# Access Compliance Report

## Public Rights-of-Way

Intersection ID: 10021320	Main Street: BLAKENEY GREENS BV	Cross Street: N/A	Location: SE
ADA ID: EE3DC48D49D6	Ramp Type: PerpDiag	Initial Pass/Fail: Fail	Overall Compliance: No
		Severity Score: 12.5

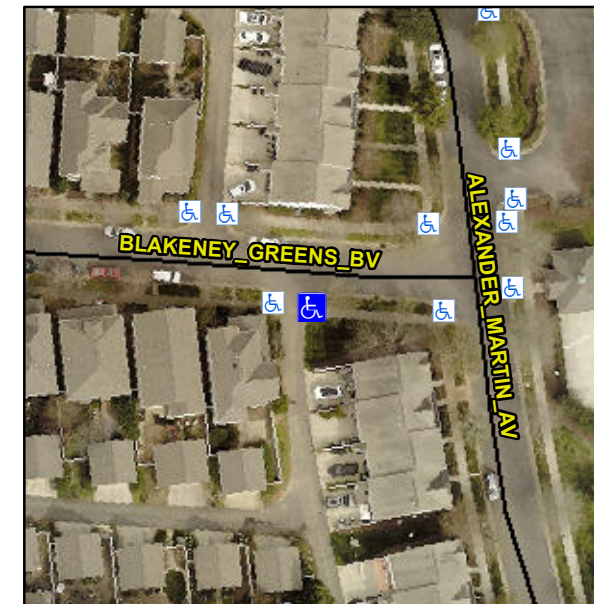
**Not Found, R304.2.2**

Compliance	Description	Data	Compliance	Description	Data
N/A	Ramp Length (in)	90.0	No	Ramp Slope (%)	8.7
Yes	Ramp Width (in)	49.0	Yes	Ramp XSlope (%)	0.9
N/A	Flare Type LT	N/A	N/A	Flare Type RT	N/A
N/A	Flare Slope LT (%)	N/A	N/A	Flare Slope RT (%)	N/A
N/A	Flare Traversable LT?	N/A	N/A	Flare Traversable RT?	N/A
N/A	Landing Length (in)	N/A	N/A	DWS Provided?	N/A
N/A	Landing Width (in)	N/A	N/A	DWS Contrast?	N/A
N/A	Landing Slope (%)	N/A	N/A	DWS Length (in)	N/A
N/A	Landing X Slope (%)	N/A	N/A	DWS Full Width?	N/A
N/A	Landing Curb? (Y/N)	N/A	N/A	DWS Offset (in)	N/A
N/A	Shared Landing?	N/A			
N/A	Gutter Ponding?	N/A	N/A	Gutter Slope (%)	N/A
N/A	Gutter Lip Ht (in)	N/A	N/A	Gutter X Slope (%)	N/A
N/A	Painted X Walk1?	No	N/A	Painted X Walk2?	No
	X Walk 1 Direction	To N		X Walk 2 Direction	To NW
N/A	X Walk 1 Width (in)	N/A	N/A	X Walk 2 Width (in)	N/A
	X Walk 1 Slope (%)	1.6		X Walk 2 Slope (%)	0.3
	X Walk 1 X Slope (%)	3.2		X Walk 2 X Slope (%)	0.3

**Remove & Replace Curb Ramp With Two New Directional Ramps or Equivalent.**
